MODEL  
2018MY  
Stinger (CK)

NUMBER  
178 (Rev 1, 1/30/2018)

## TECHNICAL SERVICE BULLETIN

SUBJECT: SERVICE ACTION: RATTLE NOISE  
FROM TAILGATE (SA322)

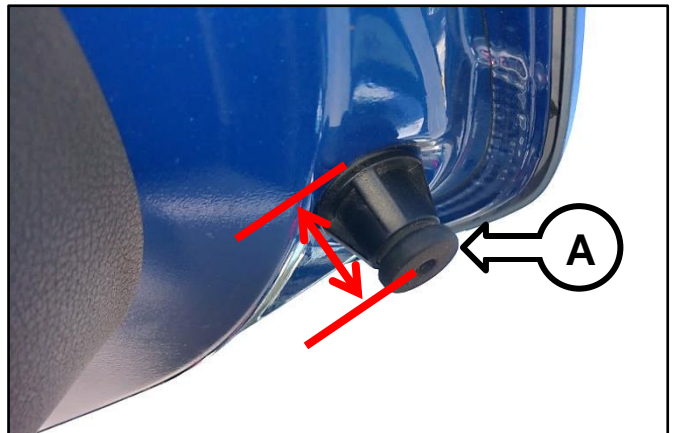
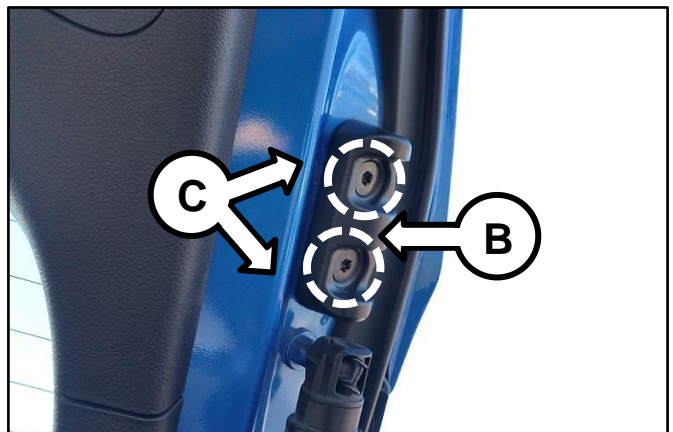
2. Check the overslam bumper (A) and adjust it within the reference protrusion specifications below. Turn the overslam bumper (A) clockwise to decrease distance. Turn it counterclockwise to increase distance if needed.

**Reference protrusion:  
0.94 – 1.02 in. (24 – 26mm)**

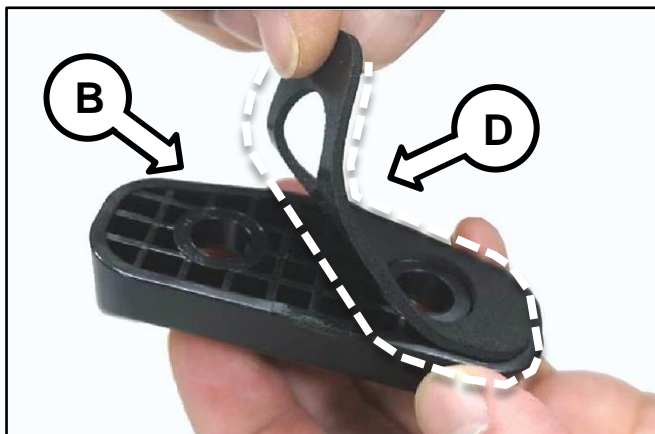
- Remove the old pad (D) and carefully center and apply the new improved thicker pad onto the guide bumper (B).

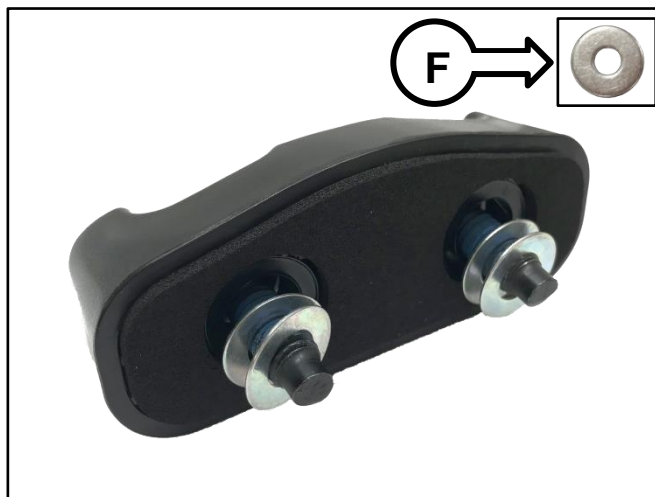
- Insert two (2) washers (F) per bolt, as shown, and then reinstall the guide bumper (B) onto the tailgate.

**4.3 – 4.7 lb.ft (5.83 – 6.37 N.m,  
0.59 – 0.65 kgf.m)**
